Docket Item #4
BAR #2018-00352

BAR Meeting
December 19, 2018

ISSUE: New construction

LOCATION: 1101 North Washington Street

Figure 3. Comparison of design endorsed at Concept Review (top) and Current Proposed scheme (bottom).

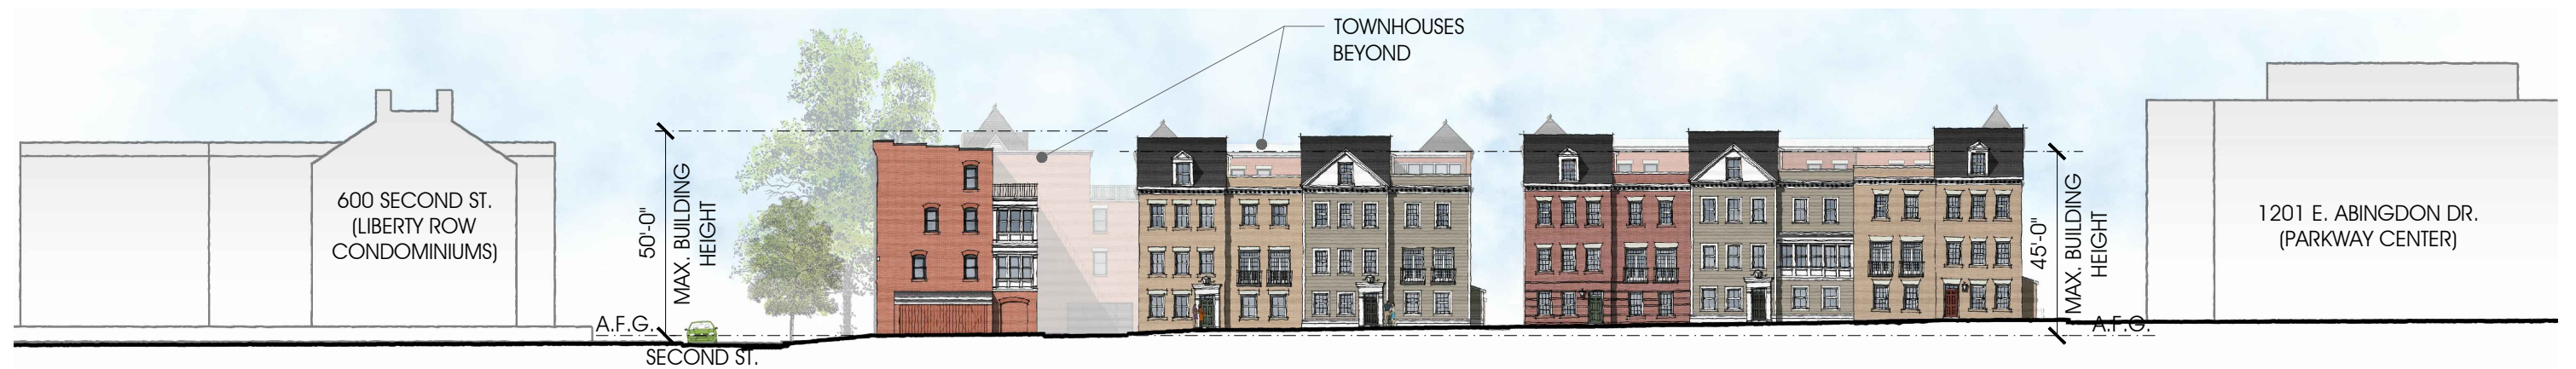
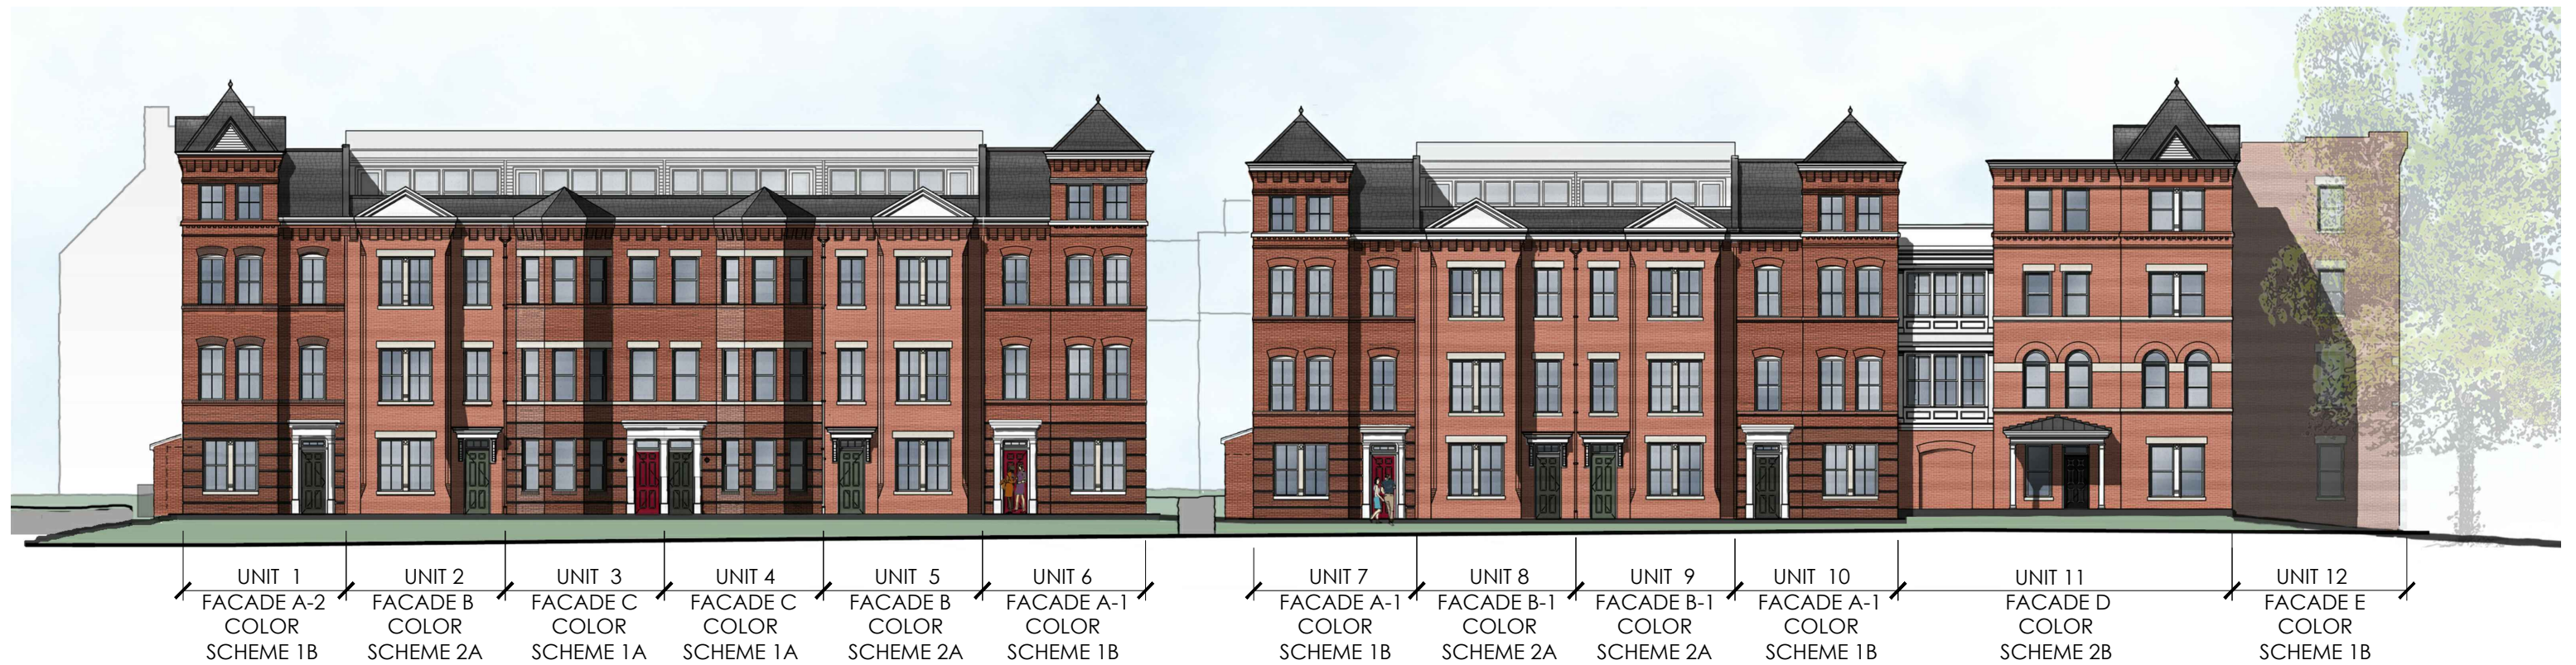
The applicant should continue to work out the details and light configurations related to the doors and windows. During concept review, the plan endorsed by the BAR featured several units on Washington Street and Second Street with arched windows at the second floor. These harmonious windows added visual interest and variety. Since that time, the applicant has removed the arched windows at all locations except for the corner townhouse unit (Figures 3 and 4). Staff finds such a modification to not be an improvement and recommends that the arched windows at the second floor be returned where previously proposed on Washington Street and also, preferably, on Second Street. Additionally, the applicant has instead moved from a double-sash with the top sash arched to a standard double-hung window with an arched transom. While staff's preference would be to return to the original arched sash design, staff finds the arched transom to be acceptable as a compromise provided the other arched windows are reincorporated into the design.

Figure 4. Comparison of design endorsed at Concept Review (top) and Current Proposed scheme (bottom) with arched windows removed.

1. Work with staff on final approval of all window and door light configurations and final approval of all window, door and lighting specifications to confirm their compliance with the Board's adopted policies. Arched windows must return to originally proposed arched window scheme.

I was struck by the greater color intensity of the samples as shown both on the sample board and Rust Orling Architecture's drawing of the West Elevation on N. Washington St., notated as 10.16.17, Page 6 compared

with drawing 9.17.18, Page 6 where the colors are more muted, lighter and more aesthetically pleasing. Further the sample board dark brick (Brick Type 1, Color Scheme 1A/1B)), reading as brown will not have

Finally, Rust Orling's drawing 9.17.18, p. 6 (West Elevation, N. Washington St.) on my computer printout shows the colors as lighter than both the above cited Orling drawings. It, too, in demonstrating a less intense
